EUT – Front View

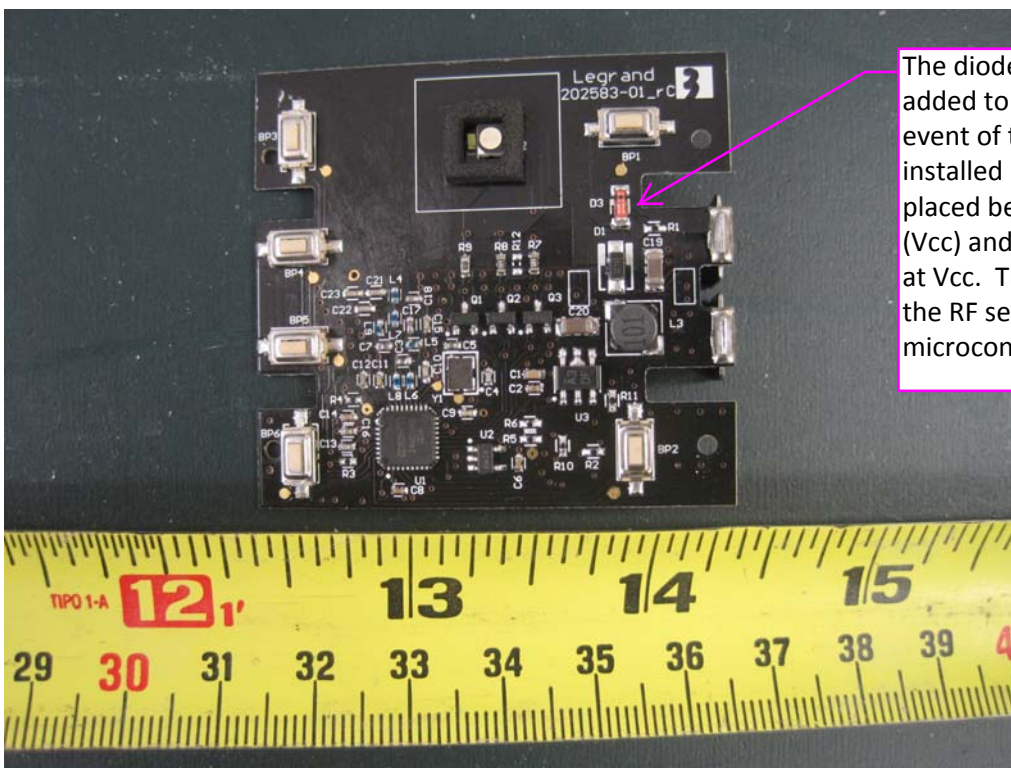
The diode pointed out here was added to protect the circuit in the event of the batteries being installed backwards. The diode is placed between battery voltage (Vcc) and ground with it's cathode at Vcc. There were no changes to the RF section or the microcontroller circuitry
